UNITED STATES PATENT AND TRADEMARK OFFICE

| APPLICATION NO. | FILING DATE | FIRST NAMED INVENTOR | ATTORNEY DOCKET NO. | CONFIRMATION NO. |
|---|-------------|----------------------|-----------------------------------|------------------|
| 10/798,480 | 03/12/2004 | Takayuki Ishii | Q80462 | 6262 |

Office Action Summary

DETAILED ACTION

FIG. 1

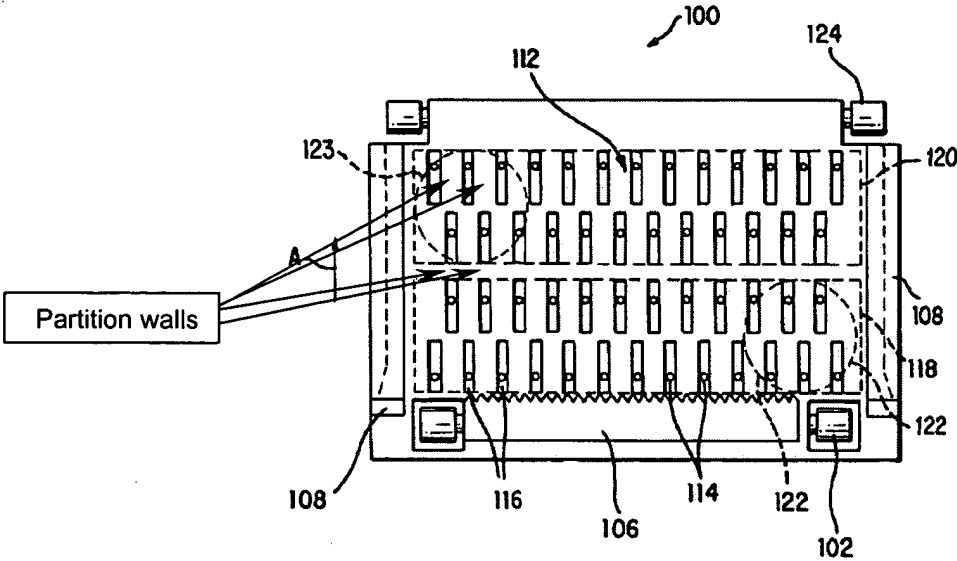
With respect to claim 2, each of the sucking chambers 116 includes a concave portion formed in the transportation surface 112 as shown in Figure 2 of Teumer, and the sucking chambers 116 are mutually partitioned by partition walls as shown below in the Figures taken from Figures 1 and 2 of Teumer:

With respect to claim 3, referring to the above Figure taken from Figure 1 of Teumer, the upper two arrows point to partition walls formed in the main scanning direction the lowest air points to walls formed in the subscanning direction.

With respect to claim 6, as shown below (Figure taken from Figure 1 of Teumer), the width of the top of the partition wall is smaller than a length of the sucking chamber 116.

FIG. 2

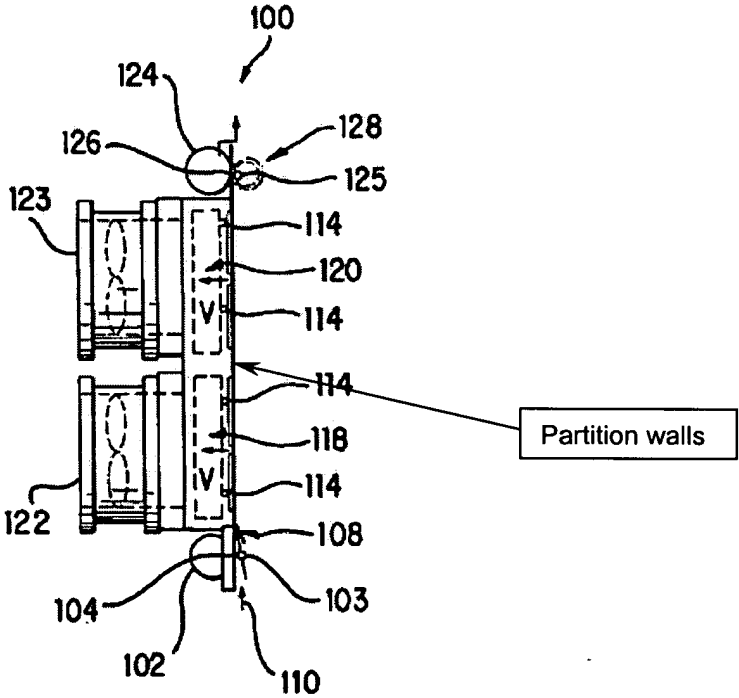
With respect to claim 4, each of the sucking chambers 116 has a sucking surface formed by an almost rectangular concave portion. It is noted that no manufacturing process will ever achieve a perfect rectangle and therefore the sucking chamber 116 disclosed by Teumer can be considered "almost" rectangular.

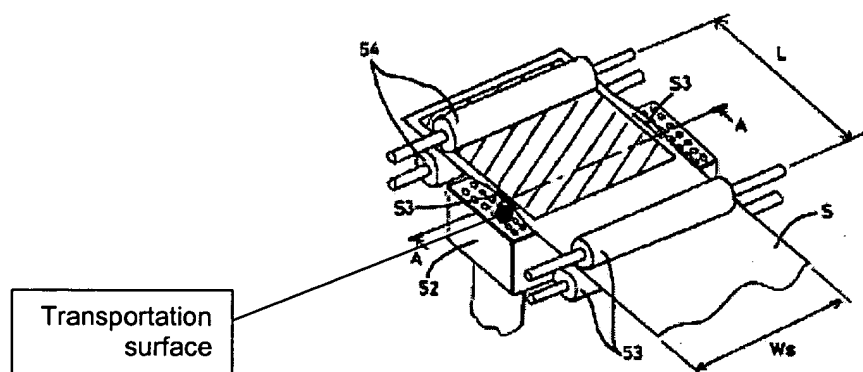
With respect to claims 9/1-9/4 and 9/6-9/8, Teumer discloses that the fixed material transportation apparatus is in a liquid fixing apparatus (printer) as shown in Figure 3 of Teumer.

【図13】

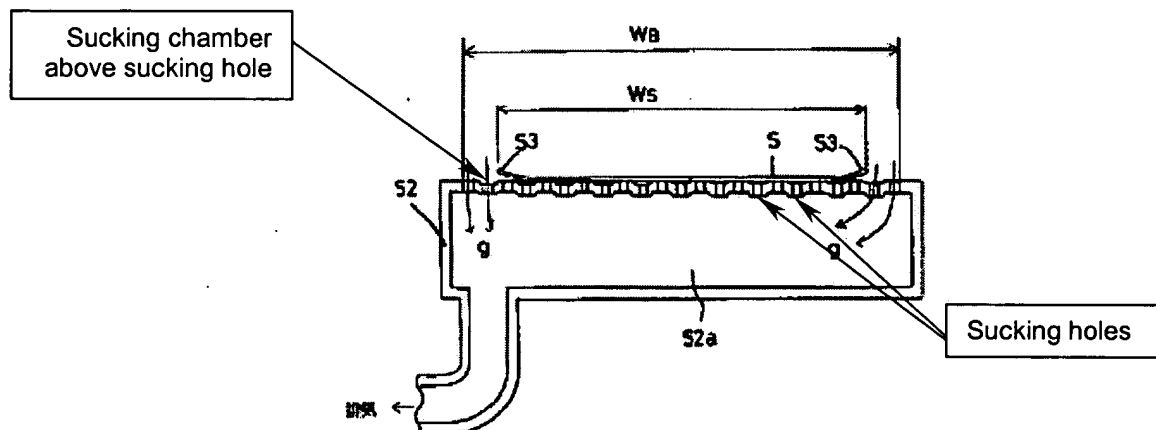
from Figures 13 and 14 of Nomura. Further disclosed is a delivering device 53 (Figure 13 of Nomura) for feeding a material onto the transportation surface from an upstream side of the sucking unit to a downstream side. Figure 14 of Nomura et al. shows that each of the sucking holes is a through hole section communicating with the decompression chamber 52a and also includes a sucking chamber having a larger area of a sucking surface opposed to the material than a sectional area of the through holes section as shown in Figure 14 of Nomura.

With respect to claim 5, as shown above and in Figures 13-14 of Nomura, the sucking chamber has a sucking surface formed by an almost circular concave portion.

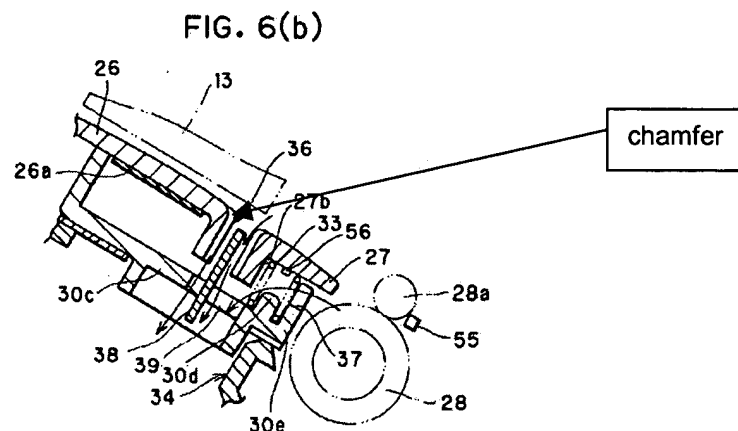
With respect to claim 18, Wotton et al. discloses a fixed material transportation apparatus including a transportation surface 204 which has dimples 203 that change in depth in a transportation direction of a fixed material as shown in Figures 2-3 of Wotton et al. The dimples 203 change in depth radially in all directions as shown in Figure 2 of Wotton et al.
